Hawthorns Area of Windy Hill Preserve Public Access Working Group

**Meeting #7 – Discuss and Confirm
Recommendations
June 2024**

Hawthorns Area Public Access Working Group
Meeting #7 Table of Contents – Revised 06/11/24
Hawthorns Area Plan

PAWG Meeting #7 Discuss and Confirm Recommendations Materials

HAWTHORNS AREA - OPTION 9

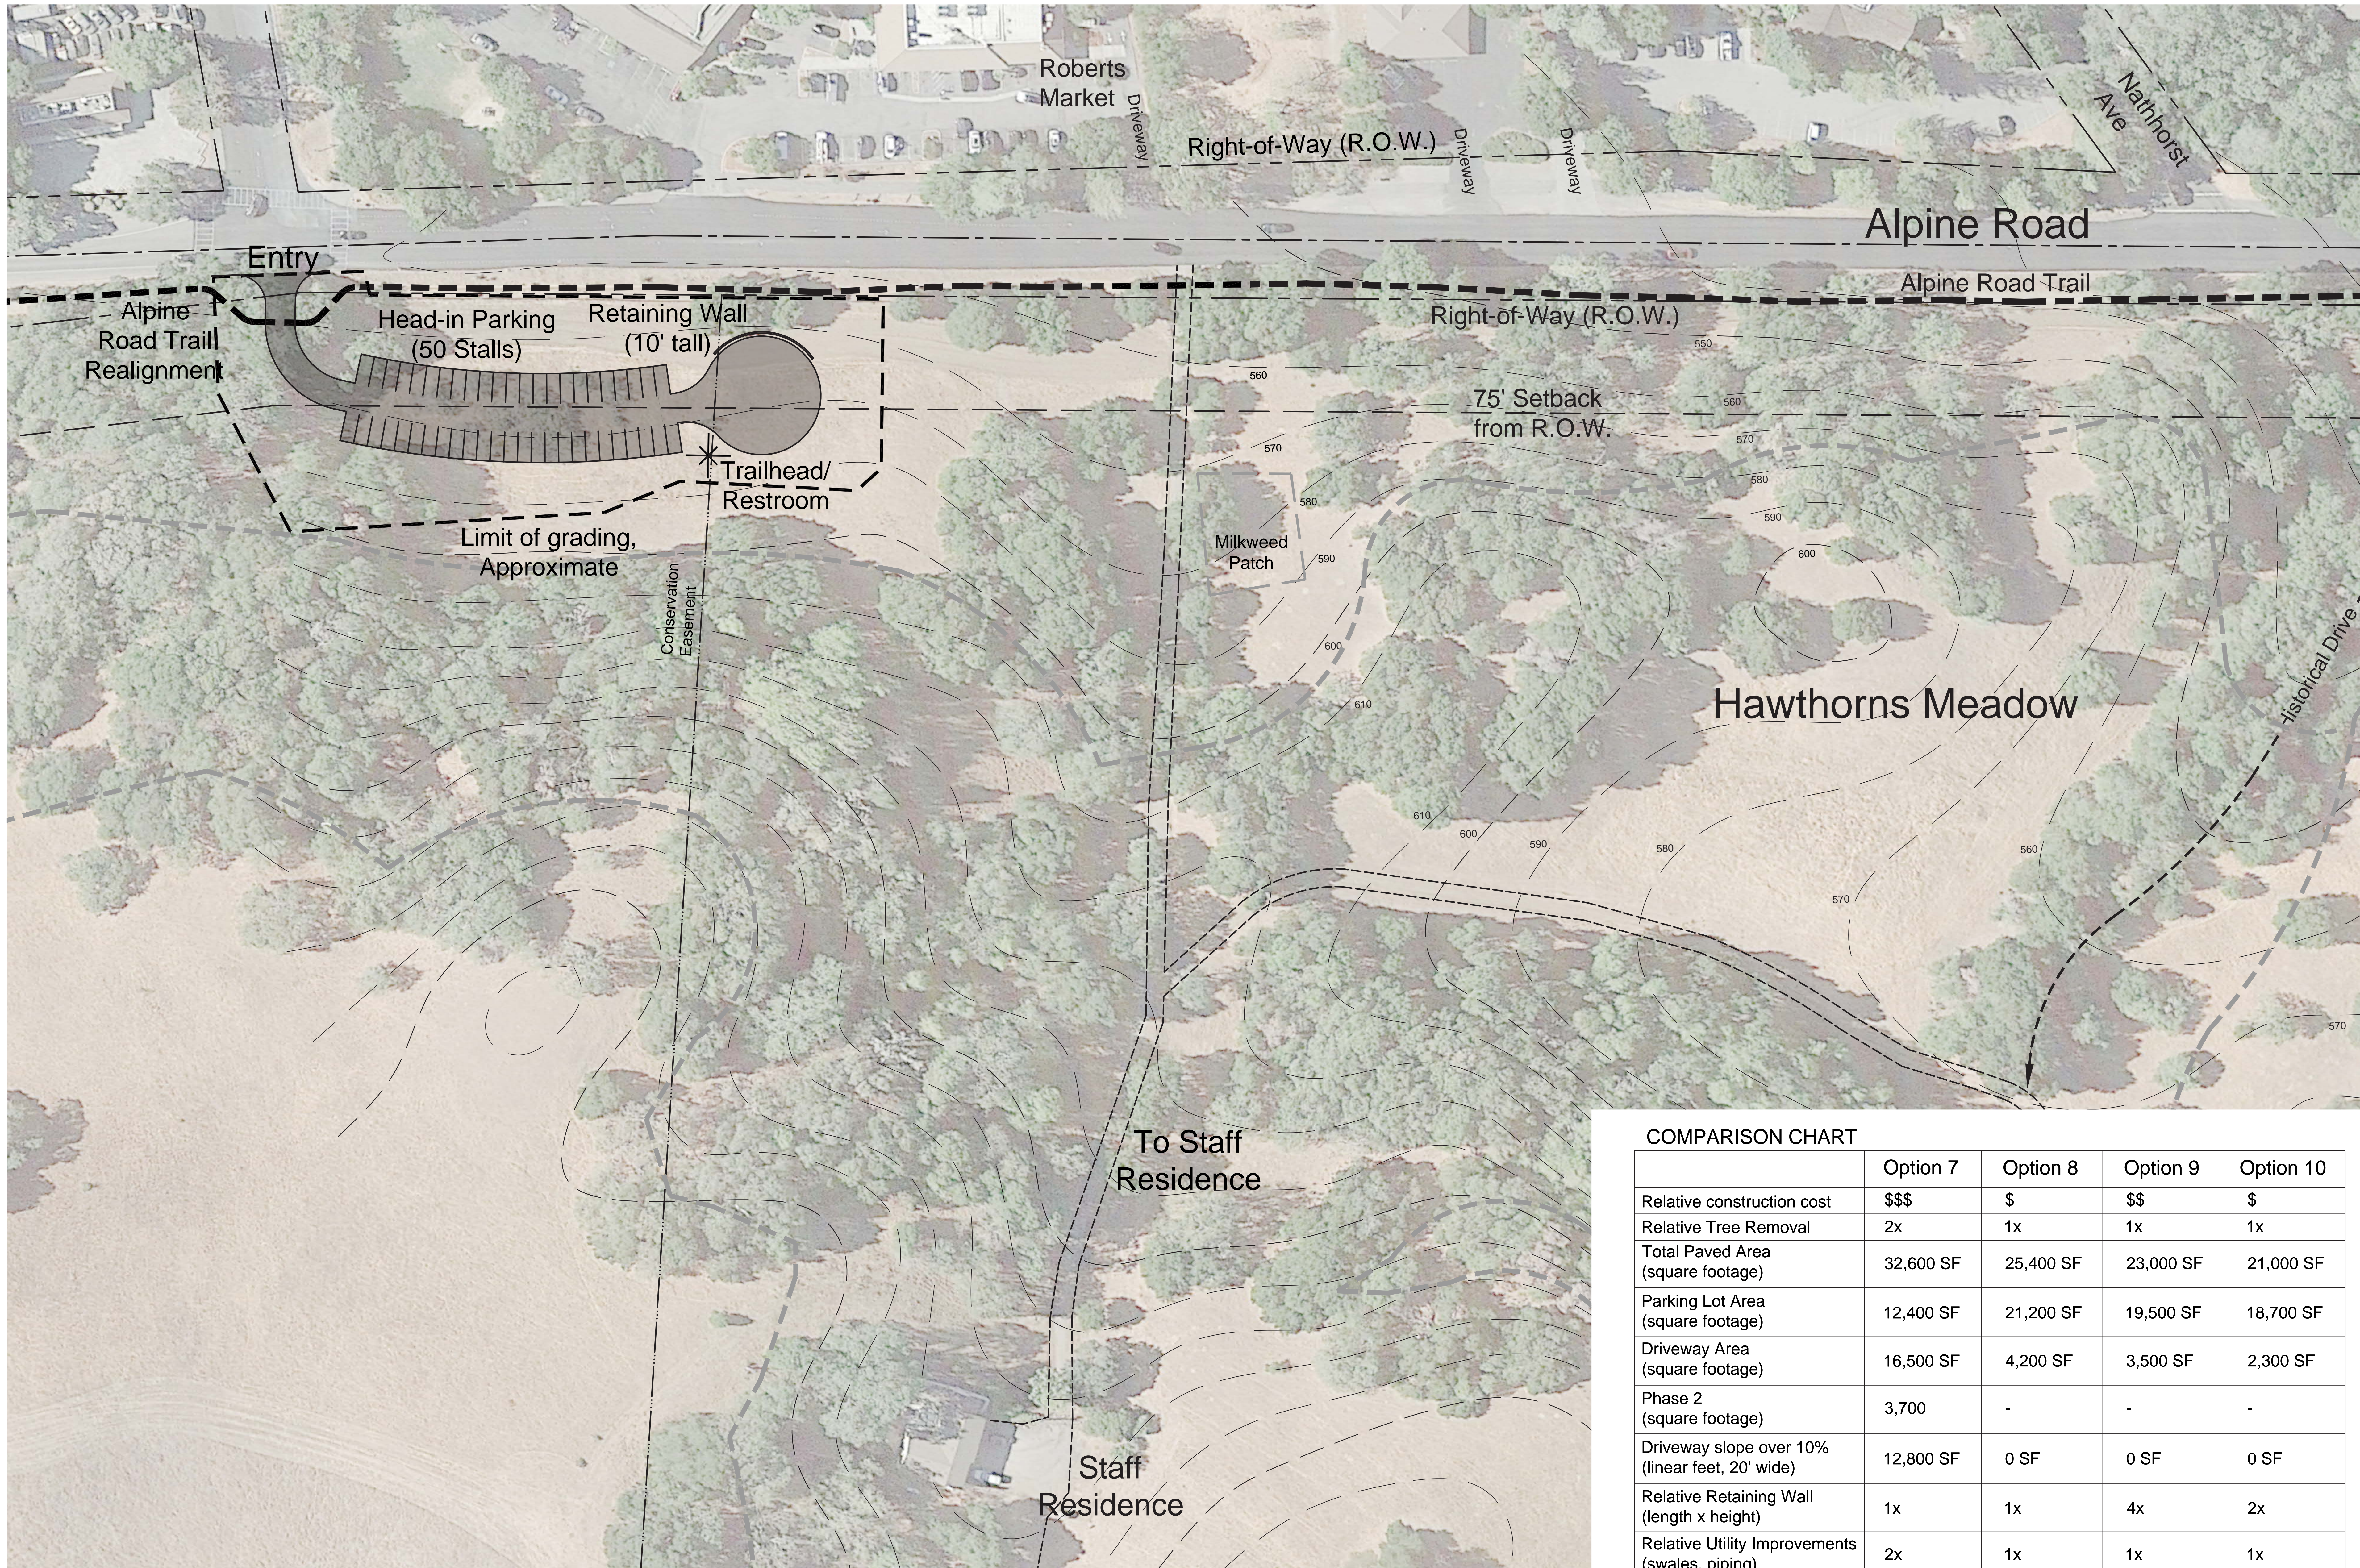
Tina Hugg provided an overview of the location of Parking Option 9 indicated by the pink flags on the ground that delineate the edge of the proposed parking area. From that location, the group observed the elevation change and the site constraints with the grades and topography and noted the proximity of the Alpine Road trail.

Option 9 allows for 30 parking stalls accessed from the existing Alpine Road entry drive to the west, with a turnaround at the west end, near the boundary line between the "Unimproved Portion" and "Improved Portion" as defined in the Conservation Easement. This site was one of the original locations evaluated for parking but limited space, the Conservation Easement, and significant topographic change that constrains the development of a flat parking area.

Tina Hugg shared that Midpen is currently in discussions with POST, the holder of the Conservation Easement, regarding the potential extension of the parking area and turnaround into the "Unimproved Portion" of the property, which is constrained by the Conservation Easement. As of this PAWG meeting (#6), Midpen is awaiting a final response from them.

- Tina identified the extent of the parking lot and associated grading.
- There were questions about the proposed turnaround in this location. Paul Stevenson explained that a parking turnaround is typically designed to allow vehicles to safely and efficiently maneuver in and out of a parking area. Fire truck access and required radii by Woodside Fire will also need to be provided. A circular turnaround is preferred by Midpen for efficient traffic circulation. Although a horseshoe-shaped turnaround could potentially provide a limited number of additional parking spaces, this configuration requires people to reverse and can lead to vehicle stacking problems. It also takes up a similar amount of space as a circular turnaround. A hammerhead turnaround in this location would need retaining walls although it is difficult to determine their height until the design is further developed. In any of these cases, there will be a good deal of grading in this location.

- If the driveway entry point were located closer to Portola Road, across from Roberts Market drive, and parallel parking spaces placed along the drive, the overall the parking yield would actually be fewer than 30 parking spaces, per consultant comment.

- Questions were raised about possibly adding more parking east of the driveway entry. Tina Hugg explained that this area is constrained and that crossing the driveway will negatively impact Dusky-footed woodrat nests and existing trees as well as introduce visitor safety concerns by mixing vehicular with pedestrian circulation. Additionally, vehicular circulation would be simplified with one parking area.

- A number of trees will need to be removed for Option 9. It will be studied in more detail at a later stage of design.

- If equestrian trailers are to be parked within the parking area, each takes up 5 car parking spaces. In conjunction with this, in the space available, the plan would need to address safe circulation of pedestrians.

HAWTHORNS AREA - OPTION 10

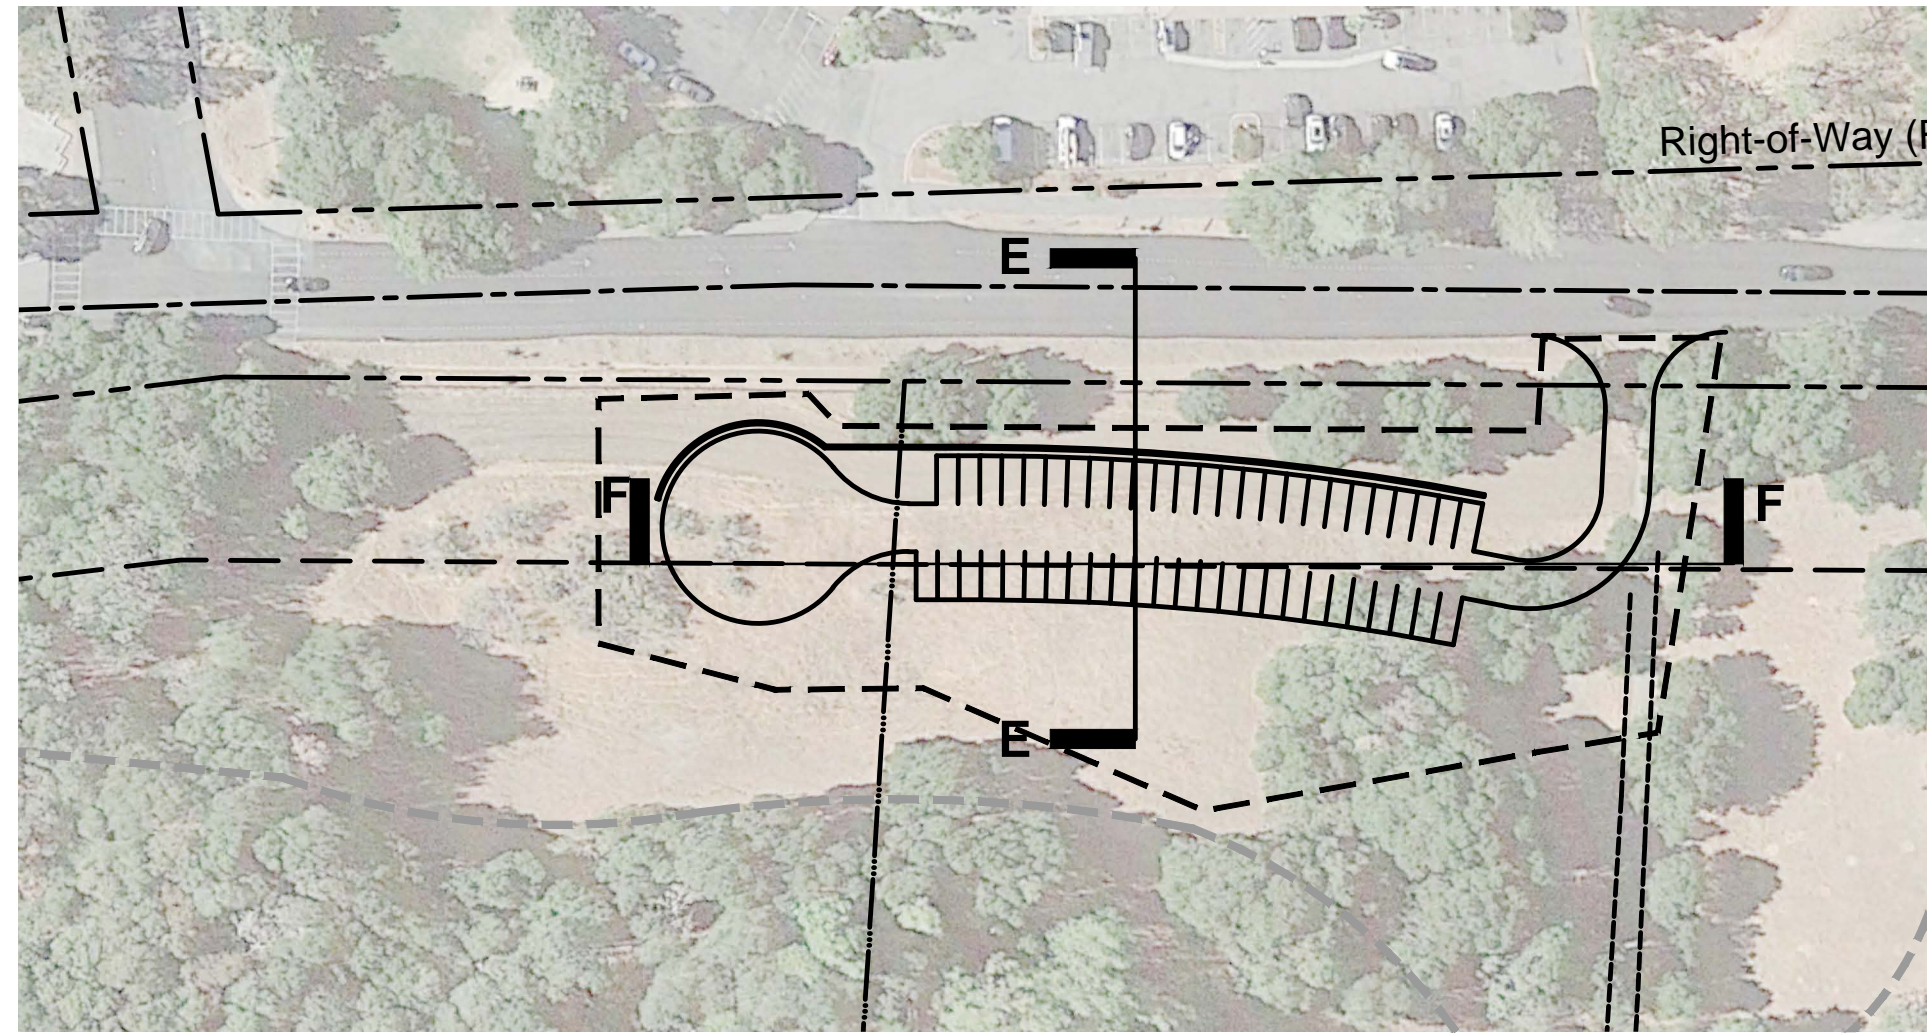
- A question was asked about “Option 10,” which had been included in the PAWG's meeting materials as a public comment from two PAWG members. This option is located across from the Roberts Market parking lot like Option 9 but utilizes two driveway entrances. The question was whether the driveway closer to Portola Road could be as an exit only driveway.
- Andrew Lee explained that the second driveway shown in the drawing, which is closer to Portola Road, has significant elevation change and line of sight challenges.
- Paul Stevenson added that the second driveway could be exit-only, but it requires Alpine Road to be part of the circulation of the parking area. The preference is to keep visitor traffic off Alpine Road.
